**CUSTOMER SUPPORT
ASSOCIATION**
Sponsored by Freightliner LLC

S60, MBE4000 & MBE900 Engine Updates

S60 EGR Broken Delta P Sensor Mounting Bracket – Ref 05 TS-53

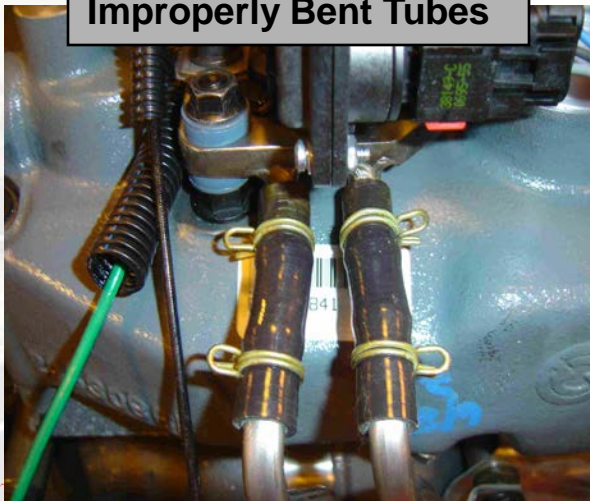
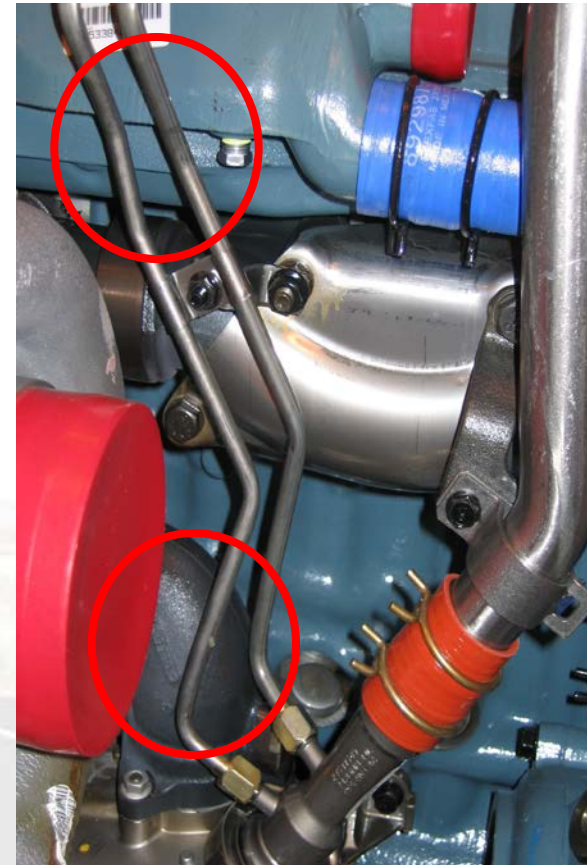
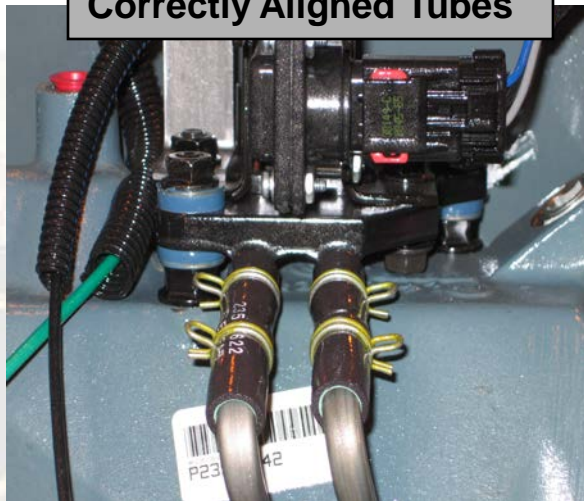
- Hose Connection Points Crack or Break Due to Improper Repair Procedures or People Stepping on it (cleaning windshield, etc.)
 - To save time, technicians will pull tubes off the bracket & bend them
 - The tubes will then be pushed back onto the bracket, which creates a stress point on the bracket & subsequent failure
- Proper Repair Procedures for Removing the Delta P Tubes
 - Loosen the four hose clamps
 - Remove the P-clips to the exhaust manifold heat shield
 - Loosen the tubes at the venturi
- S60 Service Manual was incorrect & has been fixed
- Stronger bracket new p/n 23536986 replaced p/n 23535850 effective with s/n 06R0926421 on 6/30/06

Oil Gallery Cup Plug 06 TS-10 & 06 M-05 - Background

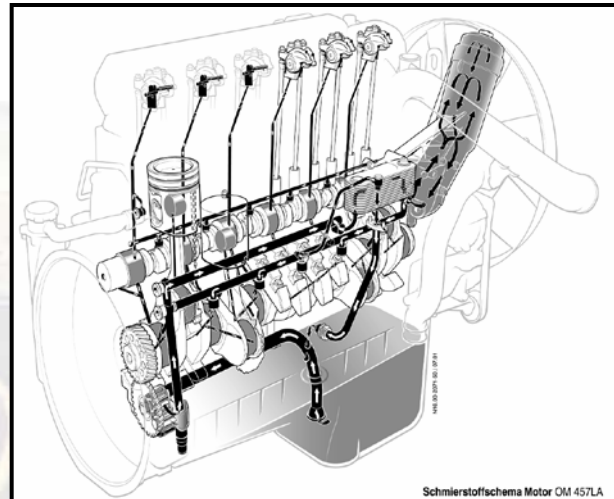
- Brazil went from a Threaded Oil Gallery Plug to a Cup Plug in May, 2005, with s/n 0460817468.
- In November, 2005, the Cup Plugs began Blowing Out in Cold Weather Locations in NAFTA.
- Brazil Returned to Threaded Plugs for NAFTA on 12-Dec-05, with s/n 0460840295
 - Block changed effective with 0460855264 on 2-May-06 resulting in plug being flush or recessed slightly in the block (no longer proud).
- Oil Travels from the Pan through the Oil Pump and up Past the Two Cup Plugs in the Rear of the Block. The Oil Pressure is Dampened by the Oil Cooler, so the Front Plug is Not a Concern.

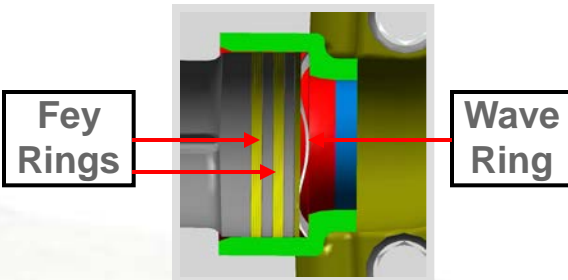
Connector Pipe – kit p/n 23536463
Change Point: 16-Oct-05, s/n 0460833653

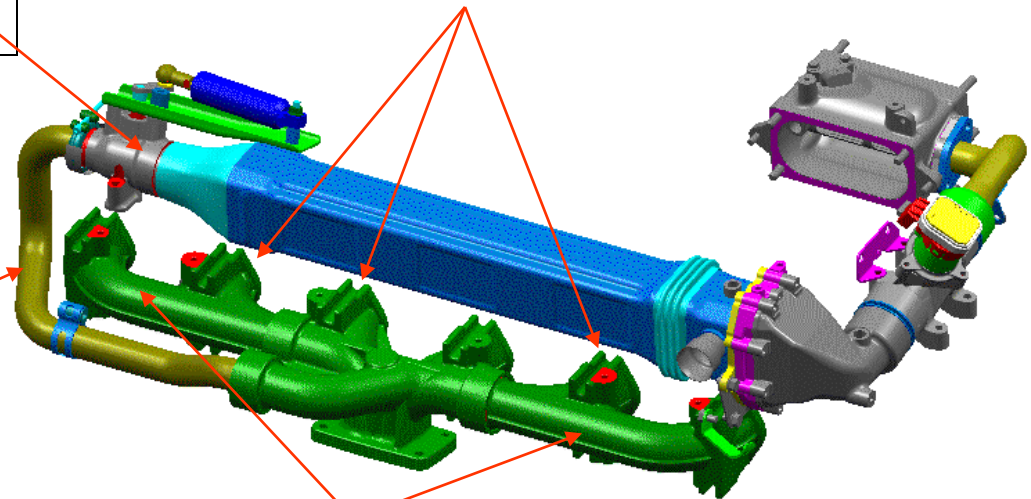
Exhaust Manifold Gaskets - p/n 4601421580
(2) p/n 4601421480
Change Point: 20-Jan-05, s/n 0460804201

EGR Temperature Sensor Tip Failure – Ref 05 TS-40

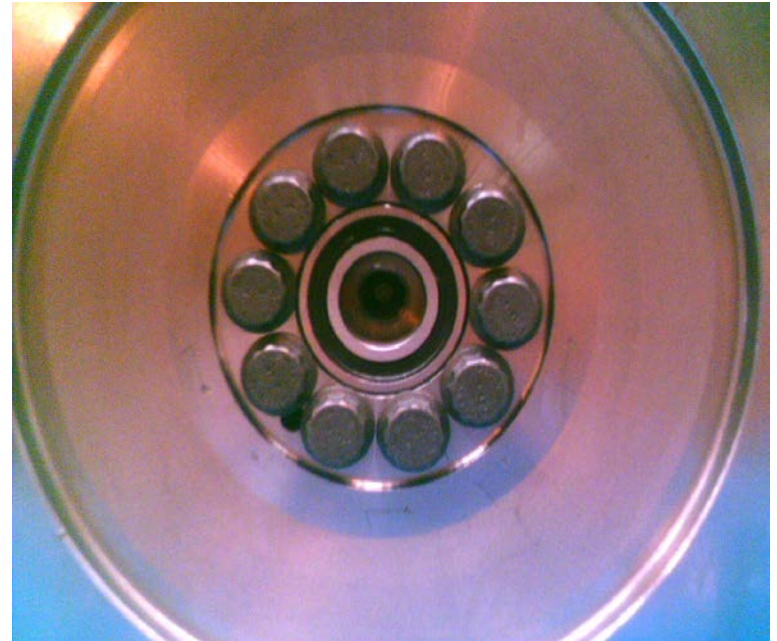
- **Tips Breaking Off & Causing Downstream Damage**
- **Will Eliminate Sensor**
 - Remove sensor, plug hole & harness, & reflash PLD.
 - Revised TS letter deals with errors in reprogramming.
 - Be careful when removing the adaptor from the housing to prevent damaged threads.
 - Investigating using cap nut instead of removing adaptor.
 - Sensor eliminated effective with engine s/n 0460829623 on 9-Sep-05.
 - If tip breaks off, make reasonable effort to find the lost tip.

New EGR valve w/new clutch material & software

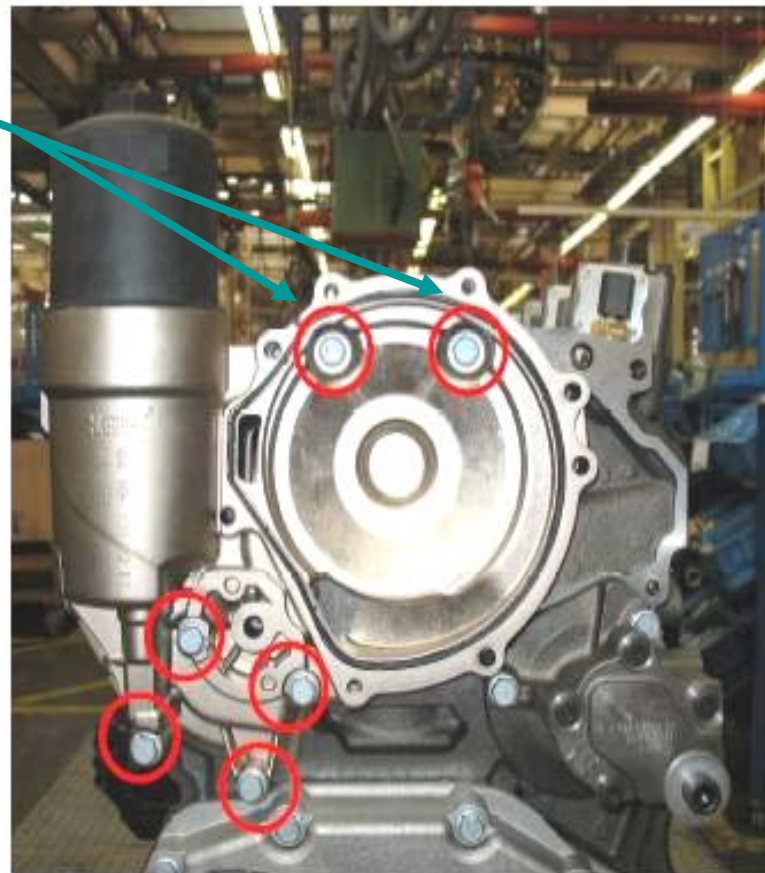
- **New EGR valve with new clutch material and software change.**
 - New clutch material holds up to high EGR temperatures.
 - Software changes within EGR valve corrects sensitivity trouble codes.

Fuel Priming Valve on Engine

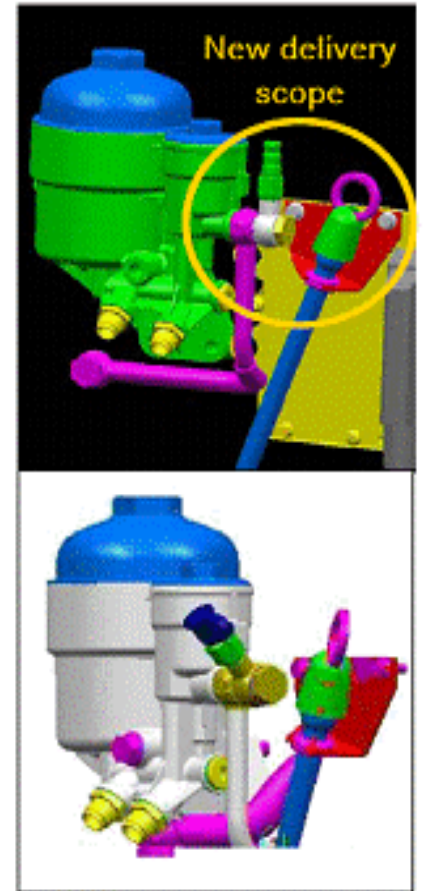
- Priming valve added to the fuel filter housing allowing OEM plants and field service the capability to pressurize the fuel system to eliminate “Hard Start” Problems
- Implementation date at NAFTA modification centers – May 23rd, 2005
- Implementation date at Mannheim – June 15th, 2005, effective with serial number 0906494959
- Parts to be released for Service for retrofits

EGR Temperature Sensor Failure – Ref 05 TS-47

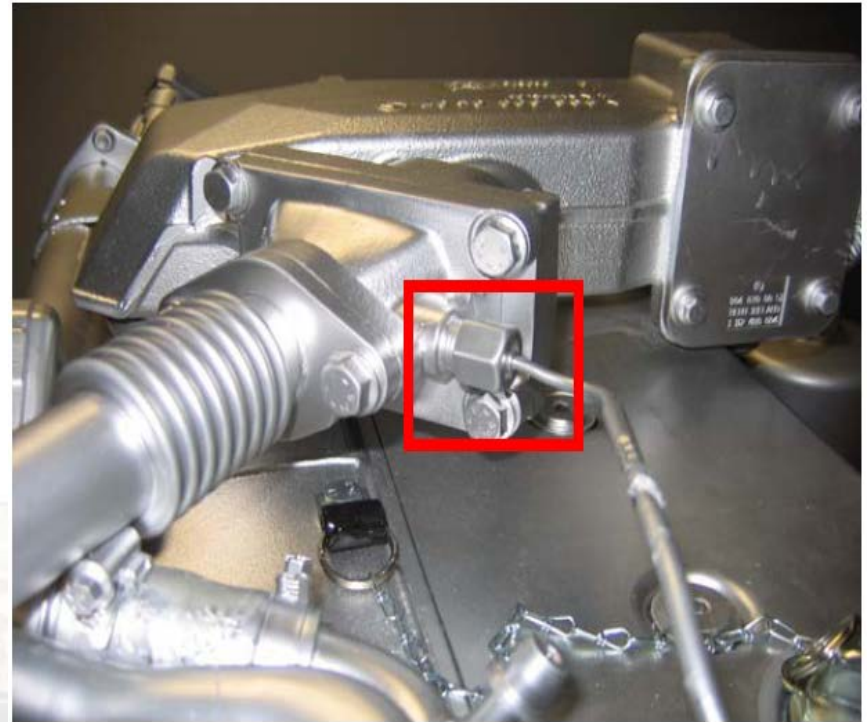
- **Sensor Stops Working, Resulting In Codes SID 146, FMI 0, 1, or 12**
- **Removed Sensor Effective With s/n 515294 on 7-Sep-05**
- **For Service, Do NOT Replace Sensors That Fail**
 - **Reflash PLD To Turn Off Sensor**
 - **Revised TS letter deals with errors in reprogramming.**
